# Access Compliance Report

## Public Rights-of-Way

| Intersection ID: 12508                  | Main Street: BELVEDERE_AV | Cross Street: CLUB_RD                   | Location: S            |
| ADA ID: ADC3542248AF                    | Ramp Type: PerpDiag       | Initial Pass/Fail: Fail                 | Overall Compliance: No |

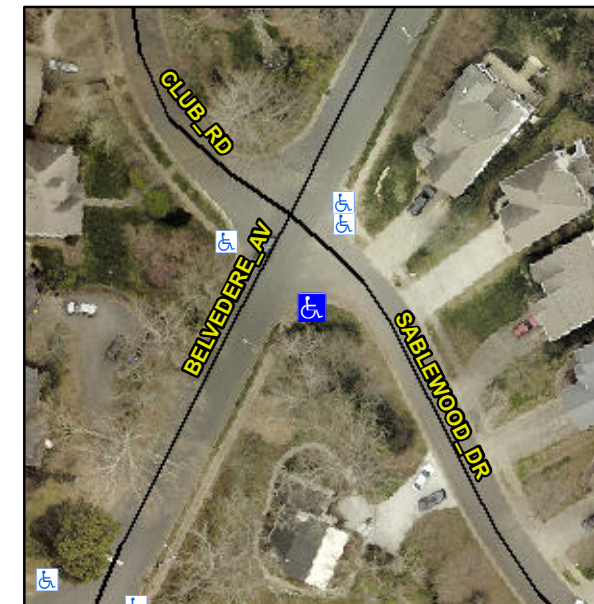
**R304.5.1, R304.2.2, R304.5.3**

| Compliance | Description           | Data  | Compliance | Description                 | Data  |
|------------|-----------------------|-------|------------|-----------------------------|-------|
| N/A        | Ramp Length (in)      | 57.5  | No         | Ramp Slope (%)              | 12.4  |
| No         | Ramp Width (in)       | 44.5  | No         | Ramp XSlope (%)             | 2.3   |

**Remove & Replace Curb Ramp With Two New Directional Ramps or Equivalent.**
